Field Service Bulletin

File: FSB10036

TurboChef C-Series ovens operational issue

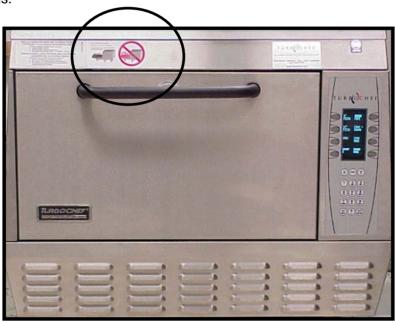
Incorrect (backward) installation of cooking platter causing door open and operational issues.

- 1. Prepare oven top trim surface next to top left sticker "Exposure to Microwaves" by cleaning and removing grease residue using Oven Cleaner.
- 2. Once you have cleaned the surface, peel back of new sticker and place next to existing sticker with a minimum of ¼" clearance. See Figure 1 for overview and figure 2 for details.
